Our Reference: **PT23061**

7 June 2024

**28 to 32 Bourke Road, Alexandria Health Centre Stage 2 SSDA
Response Report to Request for Information**

DA_BASEMENT - GENERAL ARRANGEMENT

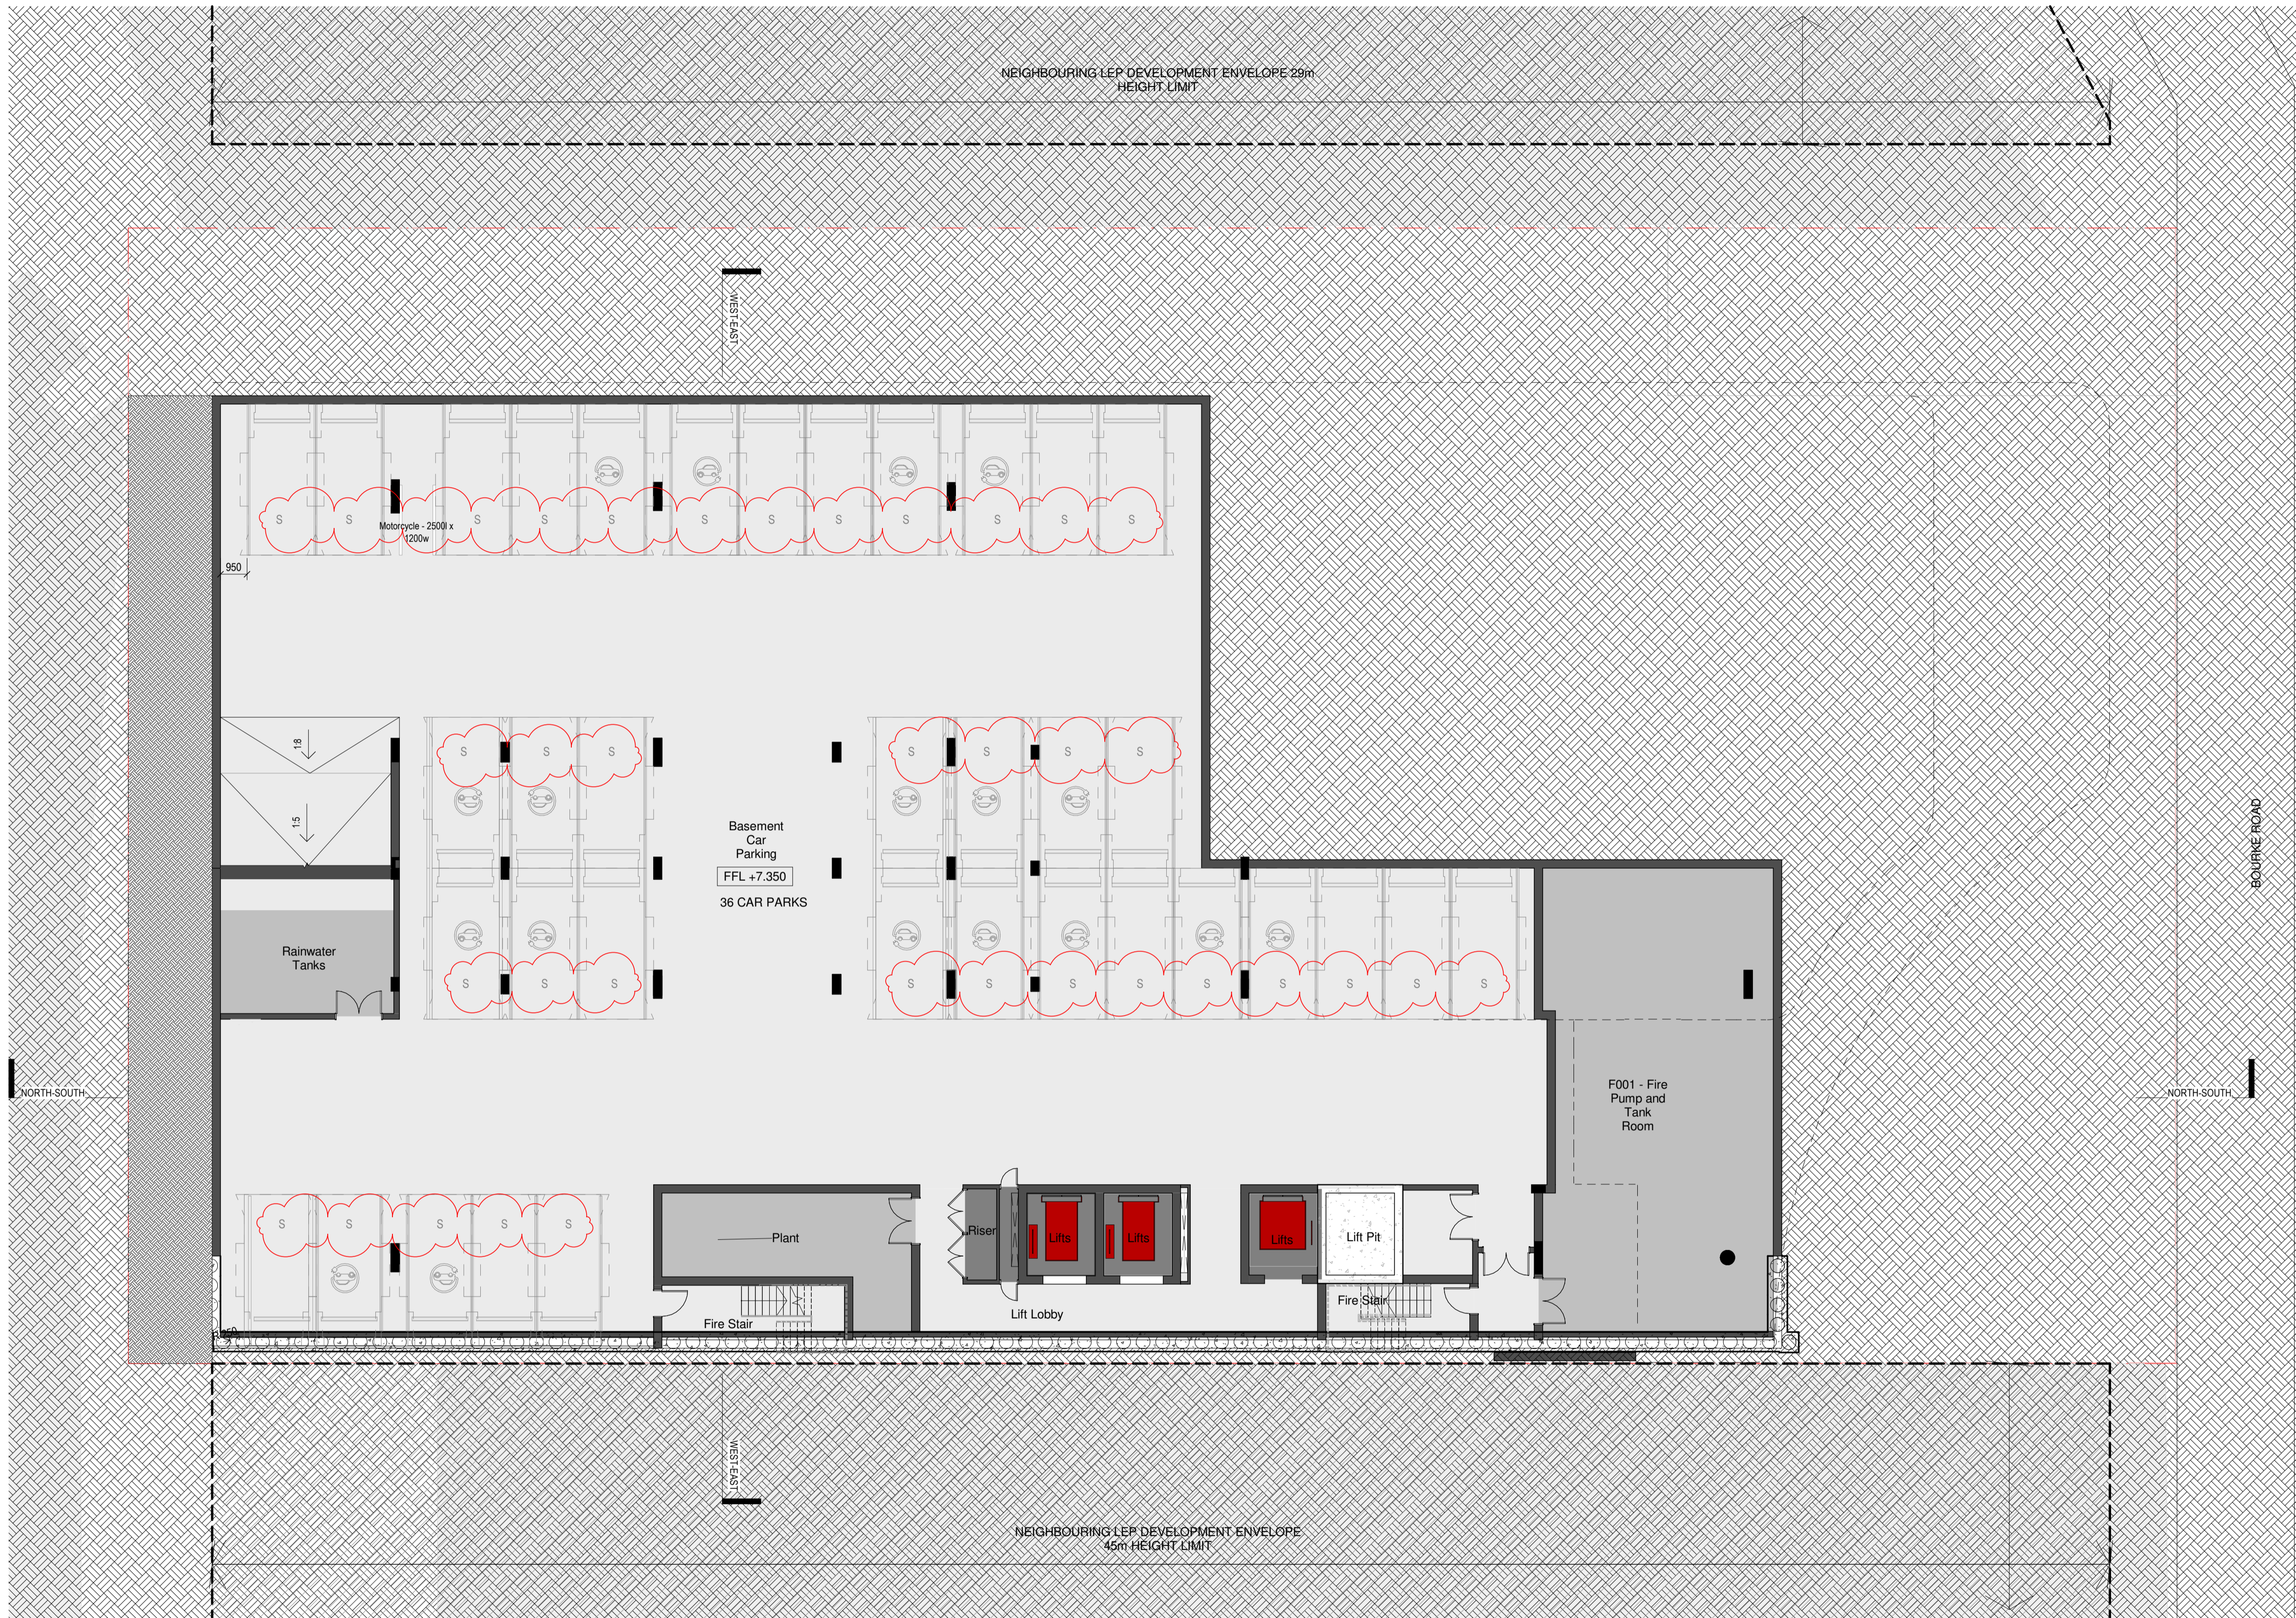
5e	It is recommended that the mezzanine and basement level car park levels be provided with a turning bay/blind aisle
----	--

The new arrangements of staff / public parking negate the need for turnaround bays as all aisles of car parking which form a cul-de-sac would be classified as 'private' (staff only) parking of which Clause 2.4.2 c) of AS2890.1 would not apply. That is, turn around bays are only required in car parks which include blind aisles greater in length than six (6) car spaces access by the *public*.

APPENDIX B – PUBLIC RAMP TURN PATH ASSESSMENT

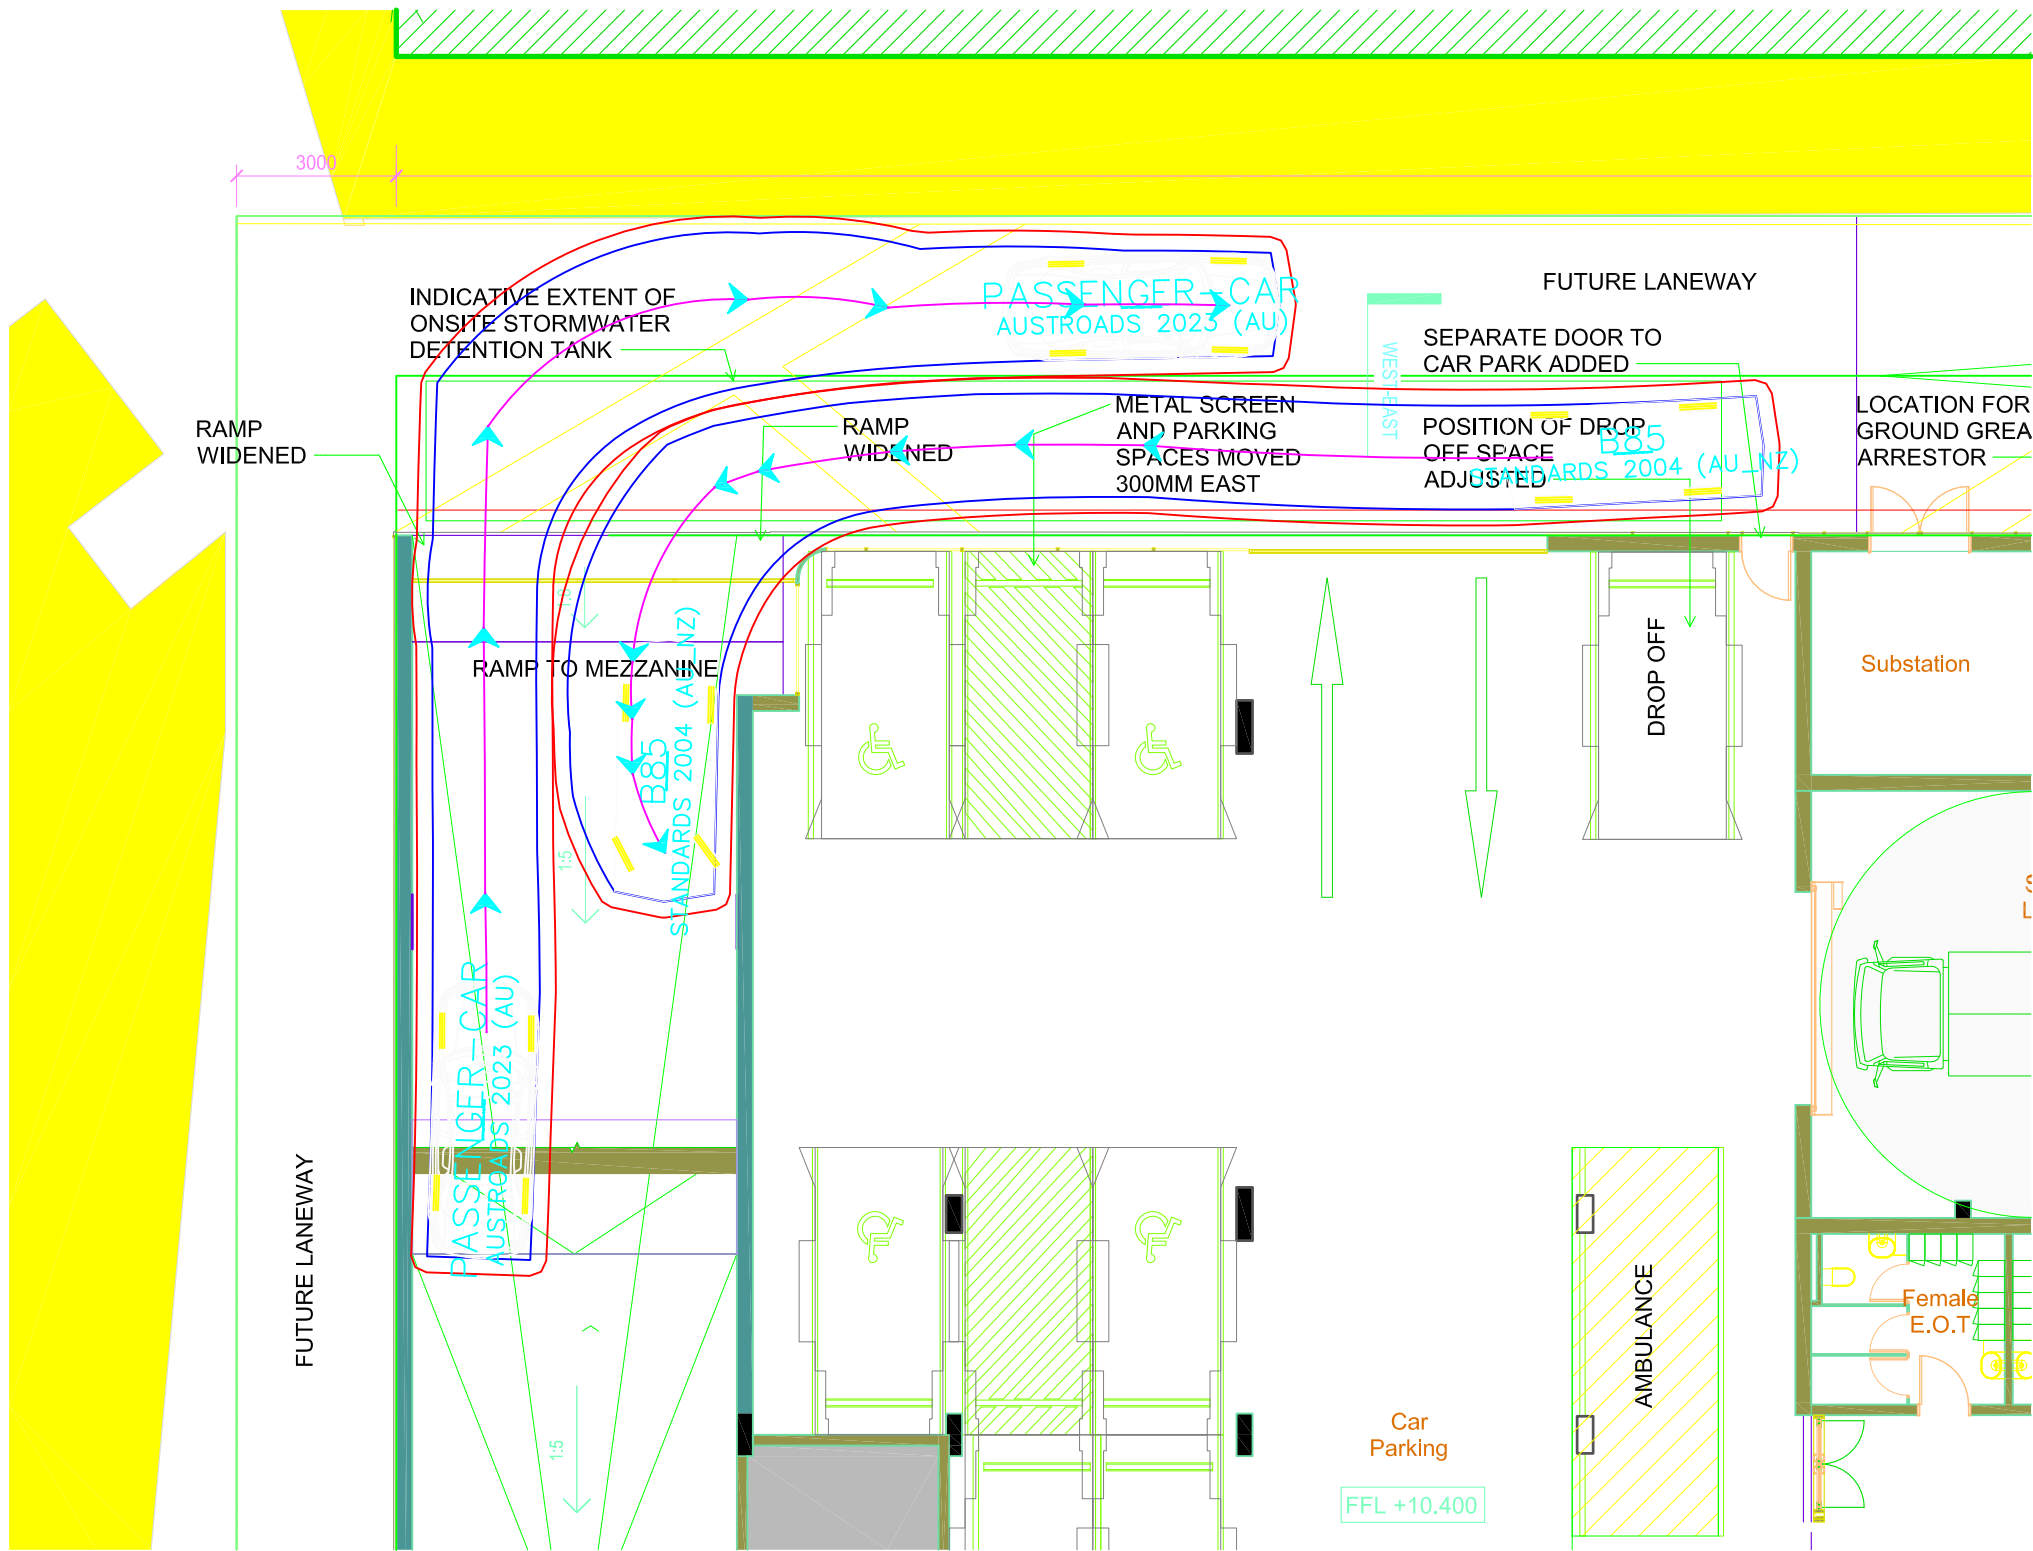
5i	The driveway access should be designed to accommodate simultaneous operation by two vehicles - one entering and one exiting side by side. A vehicle swept path analysis must be prepared to demonstrate the feasibility of two-way movements within the driveway access and ramp.
----	---

As stated above, the ramp access to the mezzanine level has been widened at the boundary to allow two (2) light vehicles to pass concurrently as per the requirements of AS2890.1. These turning paths are provided in [Appendix B](#) of this response report.
